STANDARD FIELD SERVICE BULLETIN

FSB Number	CHRAEFSB2016-14
Author	Tony Bryan
Date	03/04/2016
Subject	XT1585 Droid Turbo 2, XT1580 Moto X Force - Rear Camera - Can't Launch
Model Affected	XT1585 Droid Turbo 2, XT1580 Moto X Force
Level Of Repairs	Level 2

Figure 1 - Date Code Markings

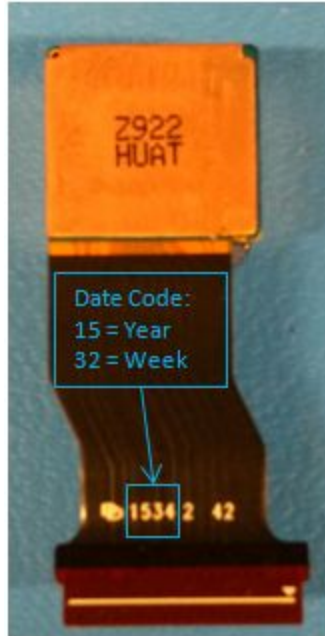
Engineering analysis of the devices found that the 21MP Rear Camera Module (Service P/N: 01018287001W) was not functioning due to internal connection issues caused by poorly formed micro-via. This is a component fabrication issue at the camera supplier.

The camera supplier has implemented process improvements to resolve this issue as of November 15, 2015 (Date Codes: 1547 or later). For details on component date code markings, see Figure 1 below.

Purge existing inventory of the 21MP Rear Camera Module (Service P/N: 01018287001W) and scrap affected date codes. Refer to Figure 1 above.
